ORDINARY MEETING 16 DECEMBER 2014	5.10
--------------------------------------	------

MATERIAL CHANGE OF USE (CODE ASSESSMENT) HOUSE – 1 MURPHY STREET PORT DOUGLAS

**Jenny Elphinstone: MCUC 15/2014 : 435581**

<u>PROPOSAL:</u>	HOUSE
<u>APPLICANT:</u>	DPA ARCHITECTS PTY LTD PO BOX 6818 GOLD COAST MAIL CENTRE BUNDALL QLD 4217
<u>LOCATION:</u>	1 MURPHY STREET PORT DOUGLAS QLD 4877
<u>PROPERTY:</u>	LOT 2 ON RP742318
<u>LOCALITY:</u>	PORT DOUGLAS AND ENVIRONS
<u>PLANNING AREA:</u>	RESIDENTIAL 1 – FLAGSTAFF HILL SPECIAL MANAGEMENT AREA
<u>PLANNING SCHEME:</u>	DOUGLAS SHIRE PLANNING SCHEME 2008
<u>REFERRAL AGENCIES:</u>	NOT APPLICABLE
<u>NUMBER OF SUBMITTERS:</u>	NOT APPLICABLE
<u>STATUTORY ASSESSMENT DEADLINE:</u>	19 DECEMBER 2014
<u>APPLICATION RECEIVED</u>	3 SEPTEMBER 2014
<u>APPENDIX:</u>	1. APPROVED PLAN(S) & DOCUMENT(S) 2. SUPPORTING INFORMATION TO REPORT

**ELEVATIONS - N.E. & N.W.**

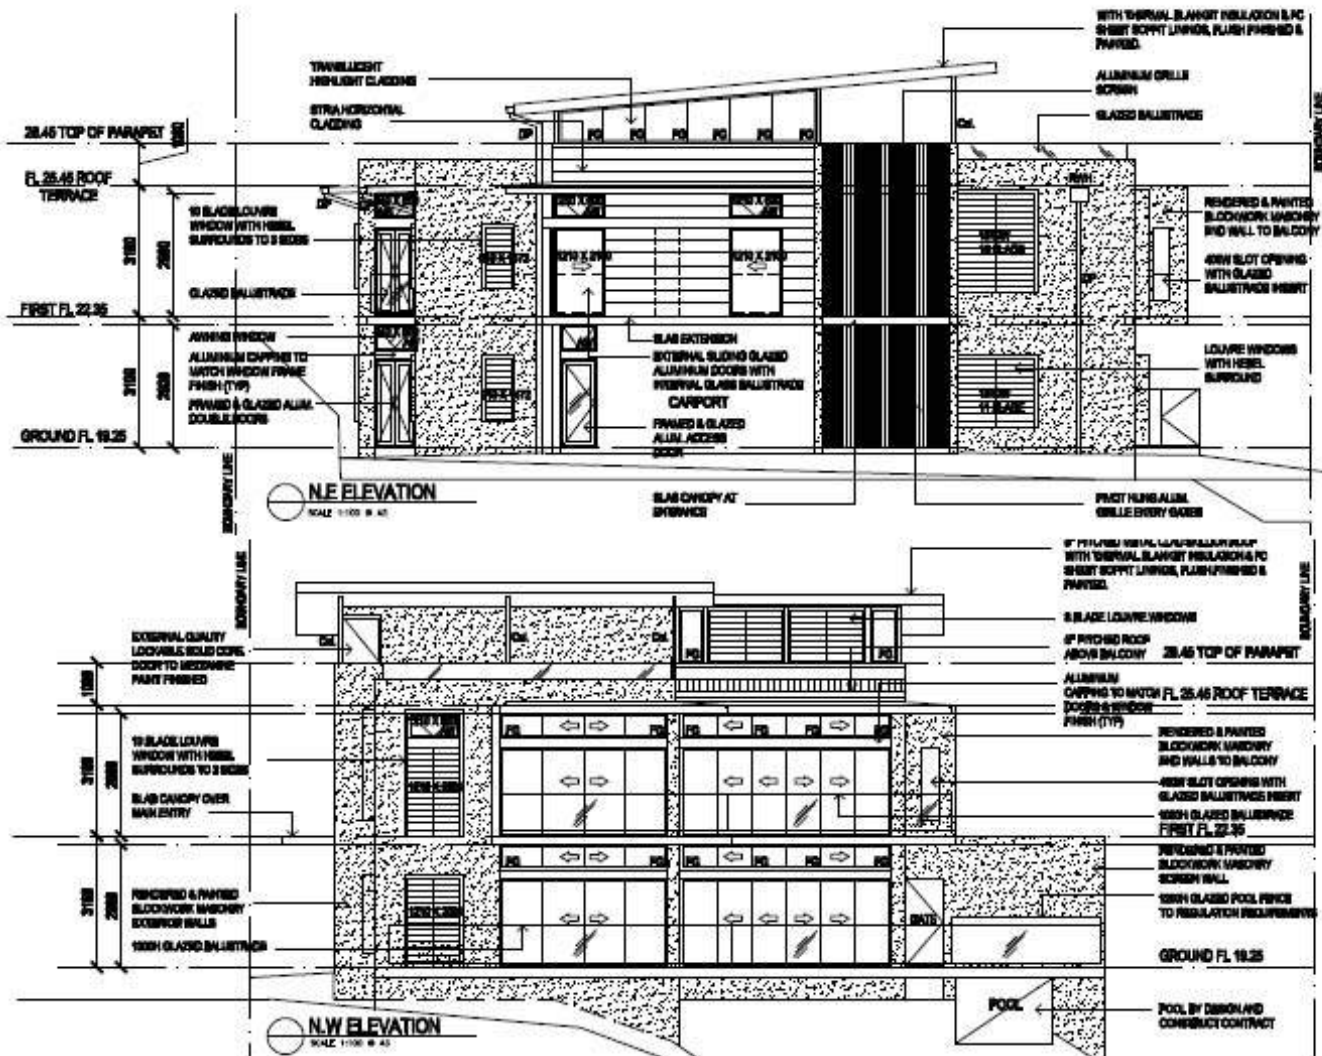
The Planning Scheme specifically defines a mezzanine constructed partly over a level is calculated as a storey. The Scheme further defines a Building as being partly enclosed by walls with a roof above. The roofed, upper deck and the mezzanine room result in the building being three storeys. The Acceptable Measure seeks a maximum building height of 6.5m with a roof area of 3.5m. The Scheme further varies height for sloping land as per the Scheme definition of 'Height.' In this instance the land is not considered to be sloping as the development is flat on ground construction. The Performance Criteria P1, which limits buildings to two storeys, is not achieved. Significant areas of open deck are provided at the ground and first floor level to provide useable open space. The roof deck is not necessary to achieve useable open space. Concern is raised with the overall bulk of the building in respect to the third level which is most pronounced to the north-western elevation. The upper deck and mezzanine level are not supported.

Concern is held with the bulk and mass of the building and the proposed finishes of predominantly glass balustrading and an off-white / light grey colour scheme. The landscape design nominates partial screening after ten years of growth. The building colours and finishes need to blend with tropical landscaping reflecting the vegetated environment sought by the Planning Scheme for Flagstaff Hill.

- ii. Reduce the building Height where: the total of all floor levels have a maximum height of 6.5 metres above existing ground level; the roof to have a maximum height of 3.5 metres; and the building is a maximum of two (2) storeys (that is, removal of the mezzanine level);

- iii. Reduce the visual bulk and mass of the building;
  - iv. Include any requirements of any further geotechnical report that are necessary to ensure the development has a low to very low risk of failure;

- vii. Provide details of the exterior colours and finishes to the house that are non-reflective and blend with the natural colours of the surrounding environment. Roofs and structures (including Water Tanks) must be of moderately dark to darker shades of green, grey, blue and brown. The building colours are to promote diversity in light and shade and create a suitable backdrop when viewed from outside the site to enhance the scenic vegetated backdrop of Flagstaff Hill;
